PERCOLATION TESTING

PROPERTY OWNER PAUL R. WIDERMAN

SUBDIVISION WIDERMAN PROPERTY LOT NO. 1

From: Thomas, Susan
Sent: Tuesday, January 11, 2022 12:16 PM
To: Tony Fertitta (tonyf@fcc-eng.com)
Subject: FW: 14945 Old Frederick Rd

Lot 1

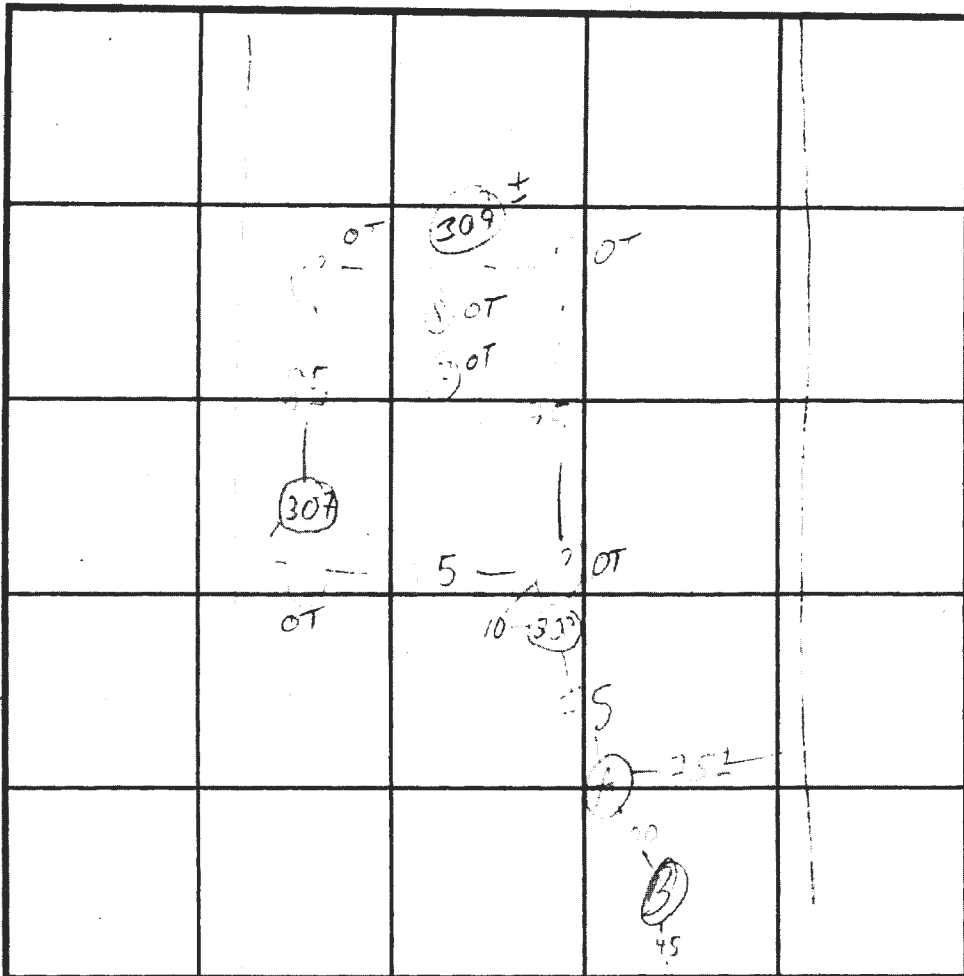
1. Adjust perc hole #s as shown
2. Hole ② @ HI @ COR OF EX. SDA) FAILS
3. Adjust SDA as shown for clay
4. Suggest moving well into lot (~50')

1. Adjust as shown

1. San error on hole ① (test plat notes R x 9')
2. all holes seem off (rotated)
3. hole ⑥ not shown
4. show septic adjacent lot

LANDSCAPING, TOPOGRAPHIC, SOILS AND PERCOLATION TEST CERTIFICATION PLAN.

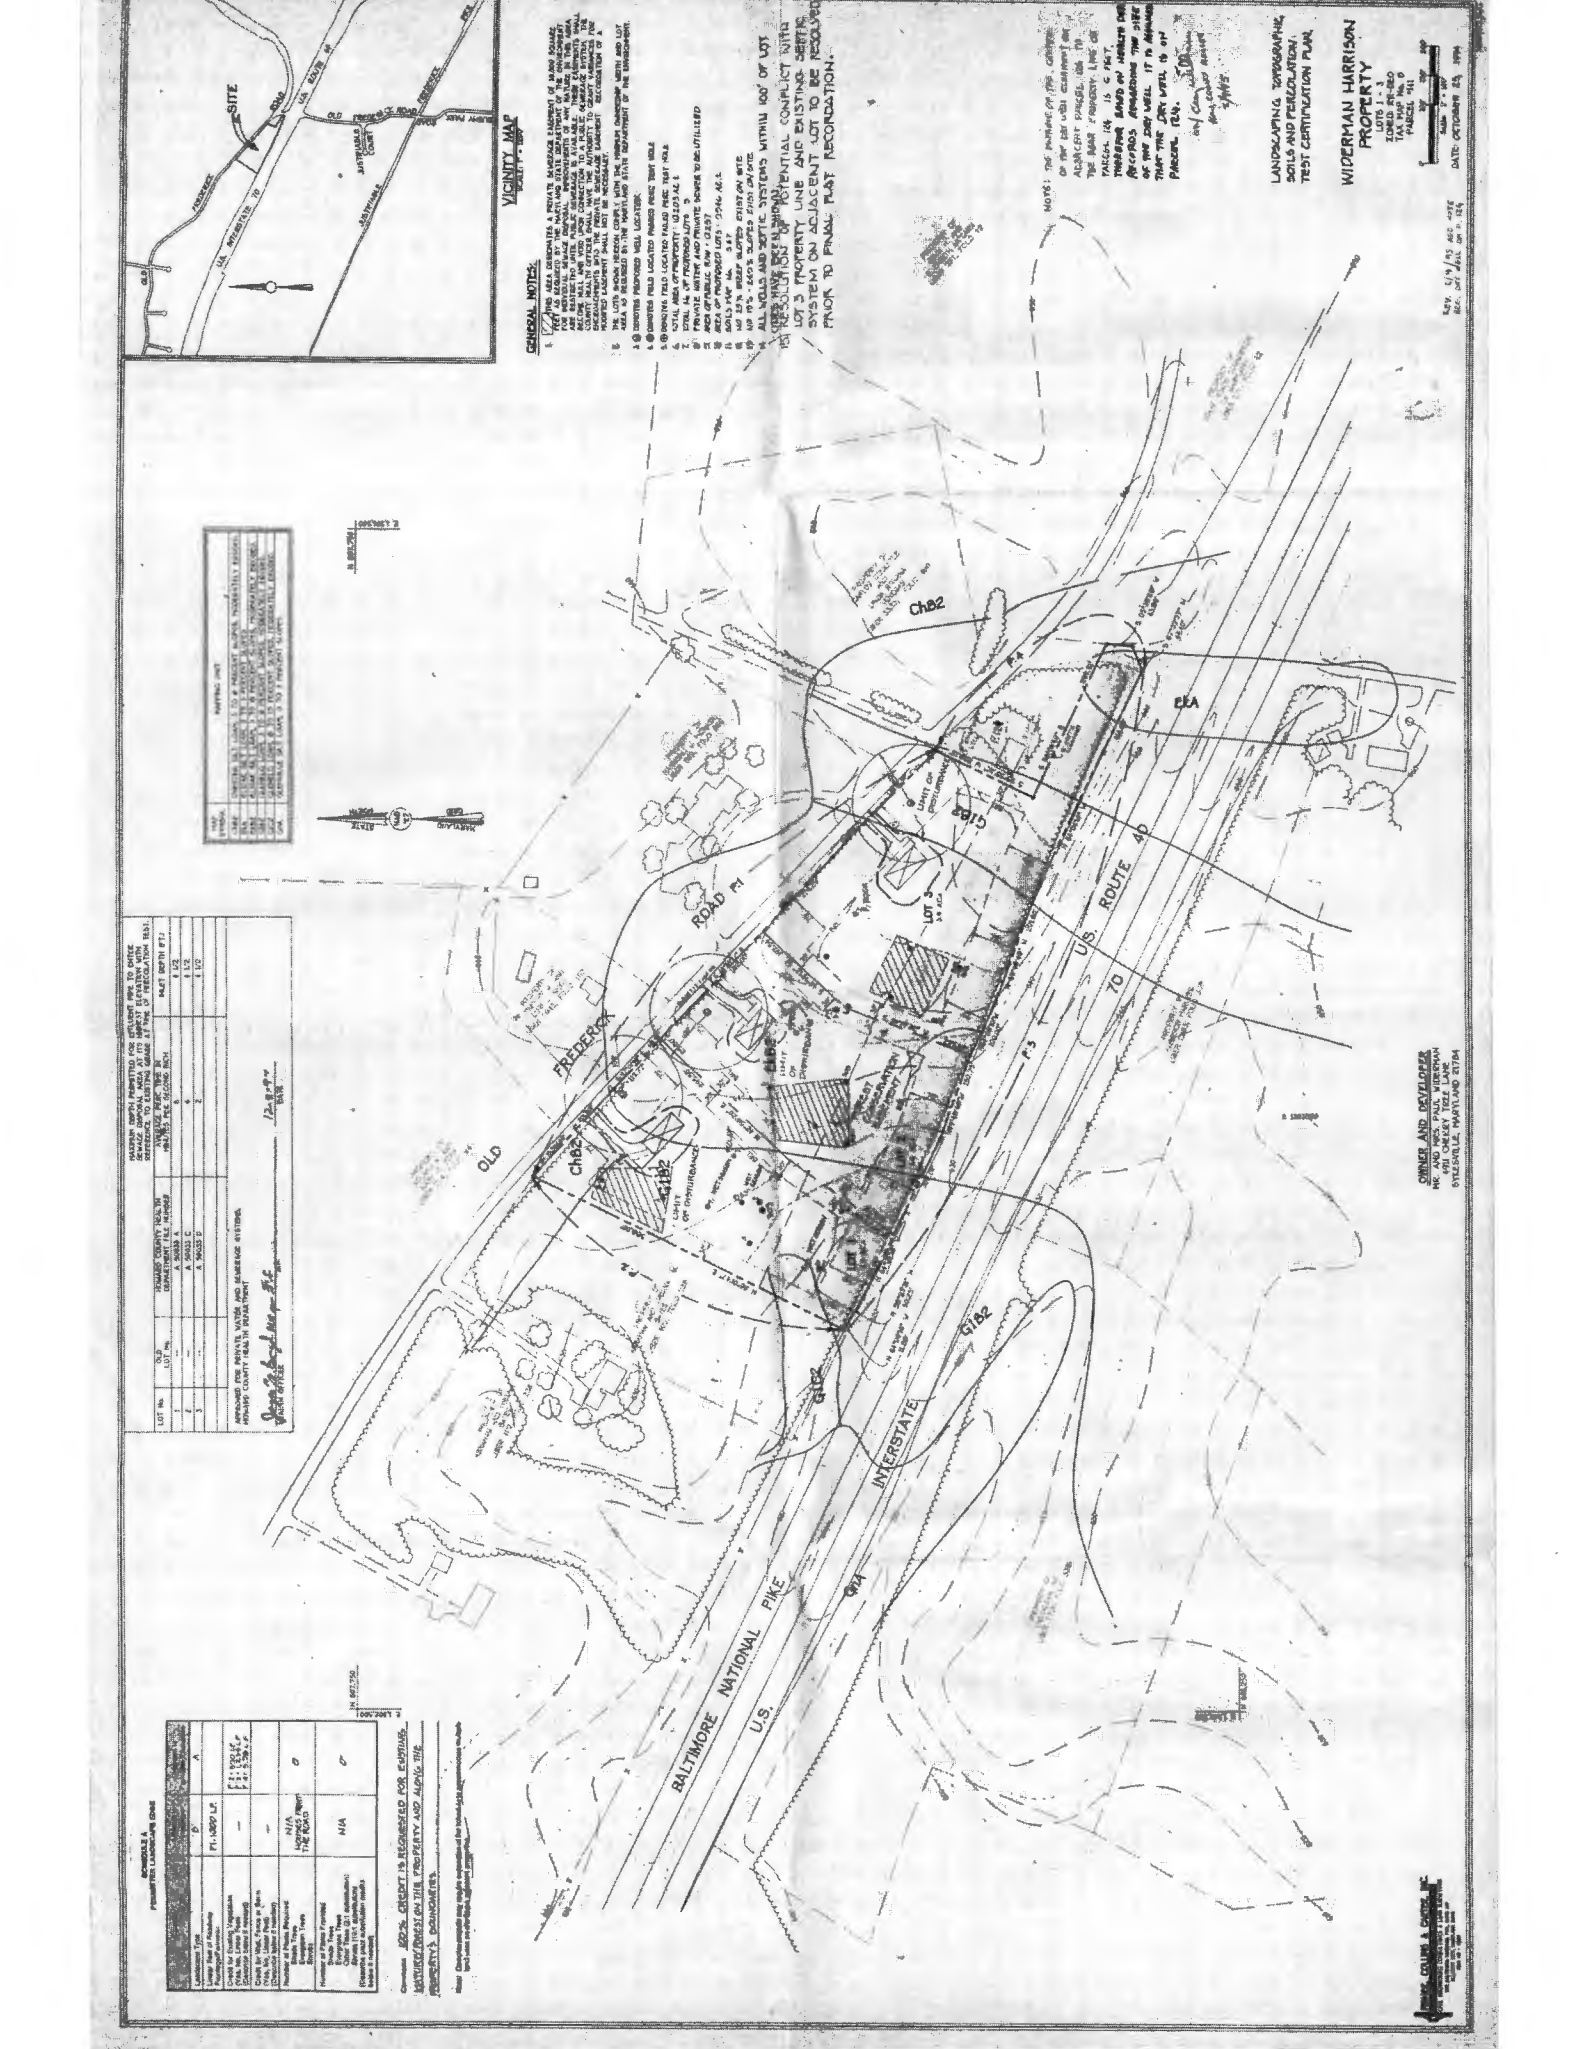
1. The perc holes should be labeled properly on the site plan.
2. The SDA should be labeled on the site plan, "existing 10,000 sf SDA."
 - a. SDA should be better distinguished than a blank white box as far as a legend is concerned.
3. Label the septic tank as 1500 Gal on the site plan.
4. The elevations are not provided along the foundational wall where the septic line is coming out.
